**Remedial Investigation and
Feasibility Study Work Plan
Revision 1**

Nevada Environmental Response
Trust Site; Henderson, Nevada

Prepared by:
**ENVIRON International Corporation
Emeryville, California**

Date:
January 10, 2014

Surrounding Facilities
 Nevada Environmental Response Trust Site, Henderson, Nevada

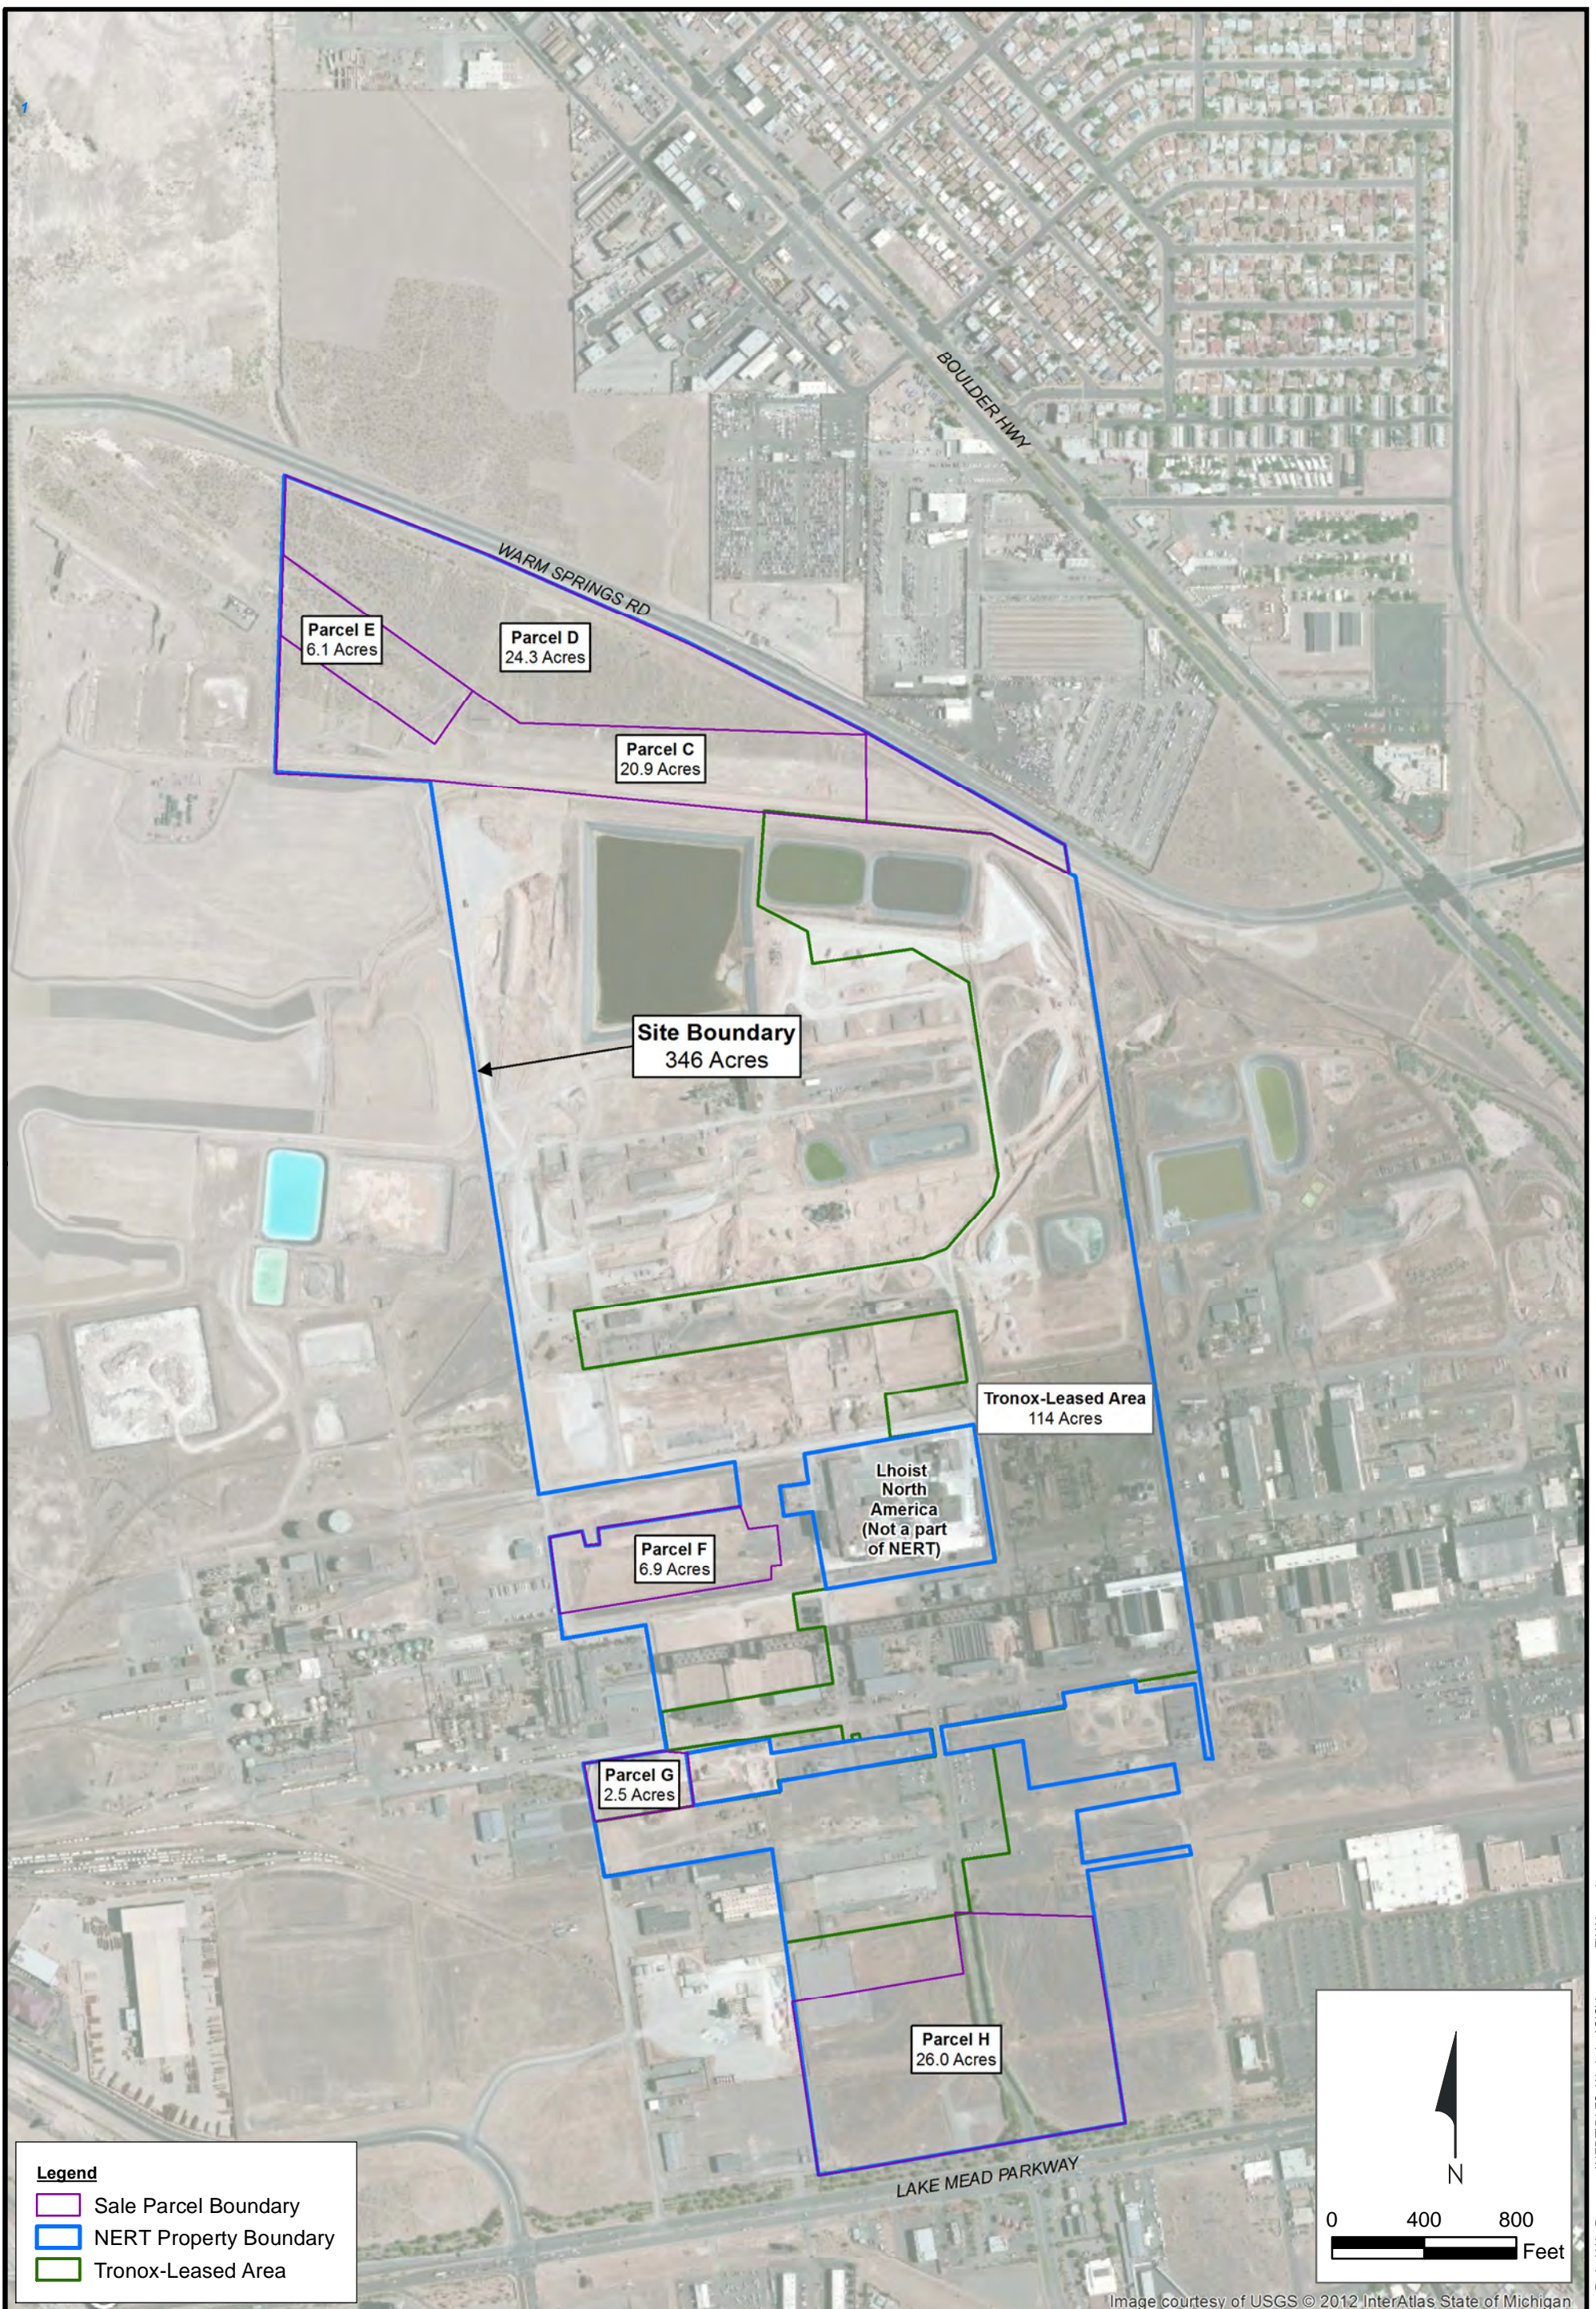
<p>71. Figure 2-1 Surrounding Facilities, please depict the BMI Dump per NDEP comments above.</p>	<p>The location of the BMI Dump will be added to Figure 2-1 of the revised RI/FS Work Plan.</p>
<p>72. Figure 4-1 Groundwater Extraction and Treatment System Flow Diagram, NDEP provides the following comments: The ferrous sulfate is added to the Lift Station 3 of AWF. Please clarify where the precipitates are removed for this influent stream and capacity of chromium removal with this method. The comment is also applied to the SWF.</p>	<p>The precipitates are retained in the activated carbon beds and are subsequently backwashed into the GW-11 pond using stabilized Lake Mead water. This practice has contributed to the solids loading of the GW-11 pond, which is discussed in response to Comment #20a. The overall efficacy of the carbon beds is also discussed in response to Comment #20b. The efficacy of the carbon beds, including the effect of the precipitates and the ultimate solids loading to the GW-11 pond, will be evaluated as part of the analysis of Remedial Action Alternatives to be included in the FS.</p>

Well Field Extraction Rates and Chromium and Perchlorate Mass Removals
Nevada Environmental Response Trust Site, Henderson, Nevada

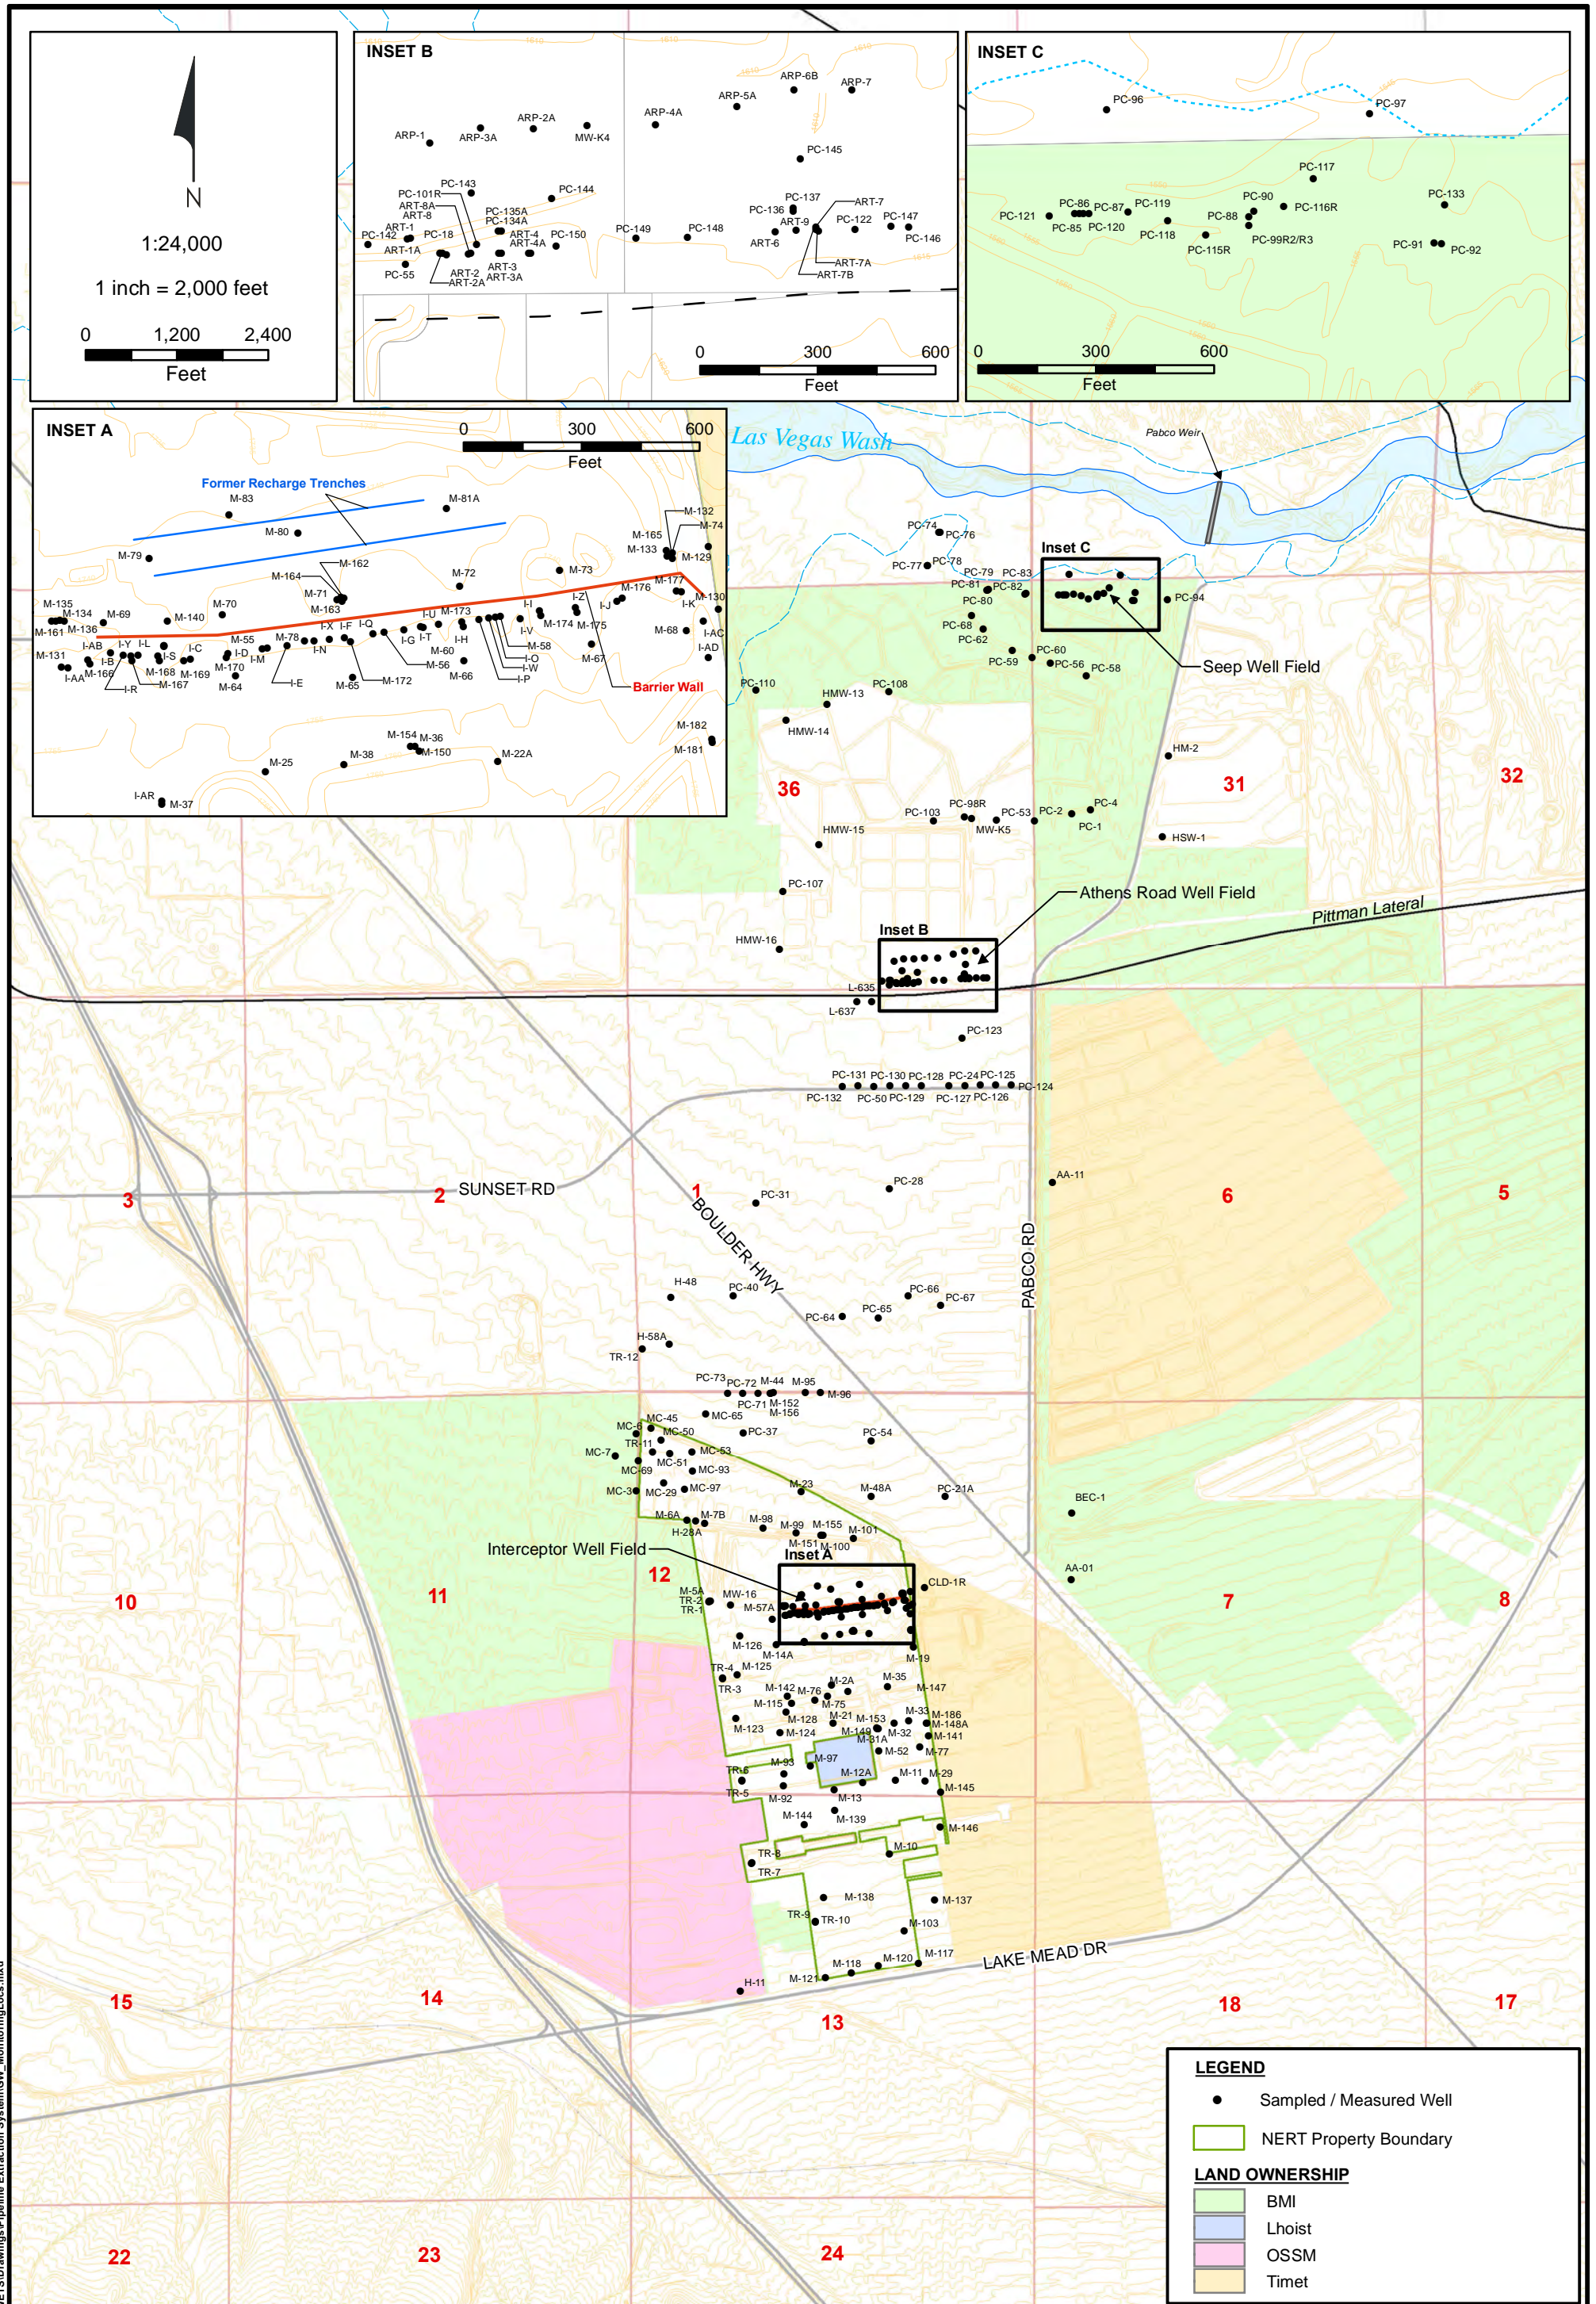
NDEP Comment	Response
73. Figure 4-5 Well Field Extraction Rates and chromium and Perchlorate Mass Removals, the total Chromium removed from the AWF has slightly increased consistently with time; however, perchlorate has not. Please discuss in the text of the revised Deliverable.	A discussion of the chromium and perchlorate mass removed from the AWF over time will be added to the text of the revised RI/FS Work Plan.

Preliminary Conceptual Site Model Diagram: Site and Downgradient Plume
Nevada Environmental Response Trust Site, Henderson, Nevada

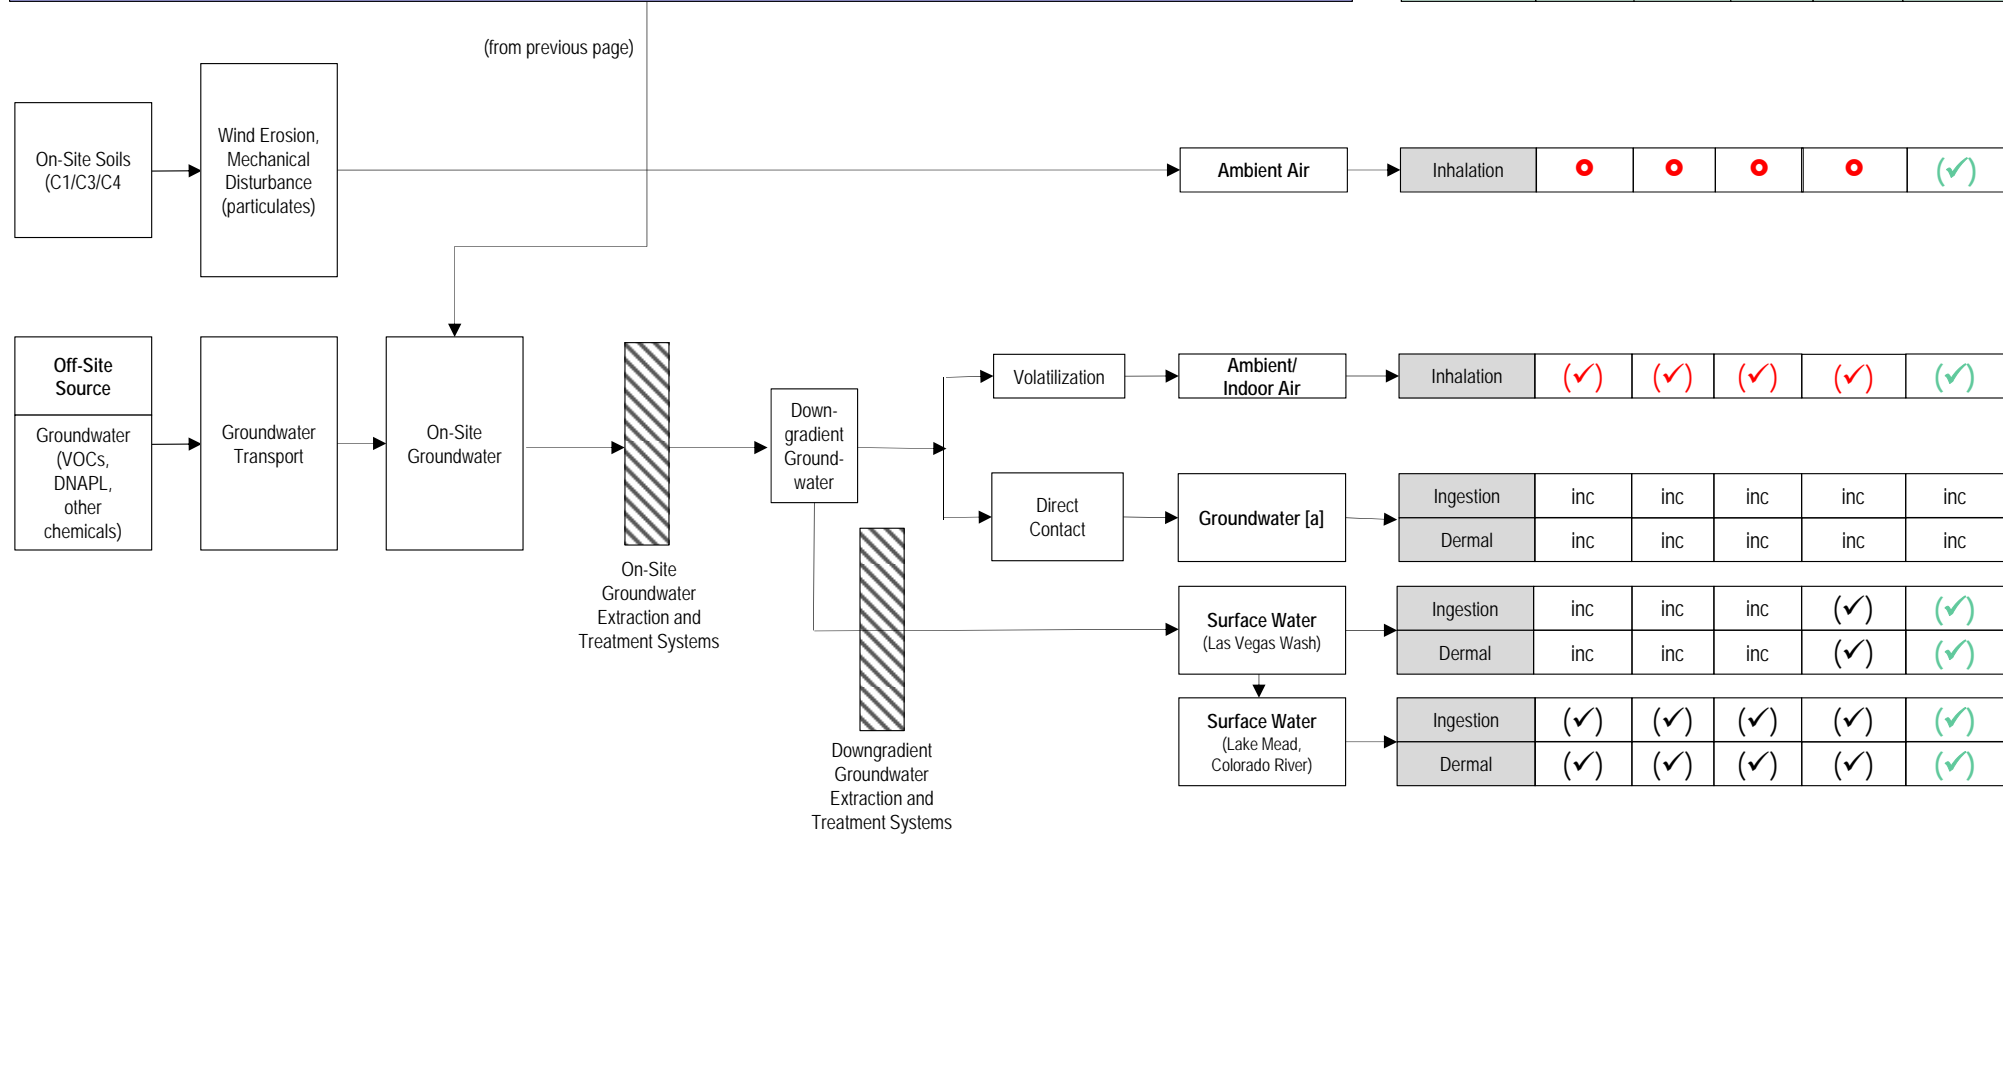
74. Figure 5-1 Preliminary Conceptual Site Model Diagram: Site and Downgradient Plume, the figure does not include ecological receptors; please refer to Figure 5-4, which indicates both terrestrial and aquatic receptors.	See response to Comment #6.
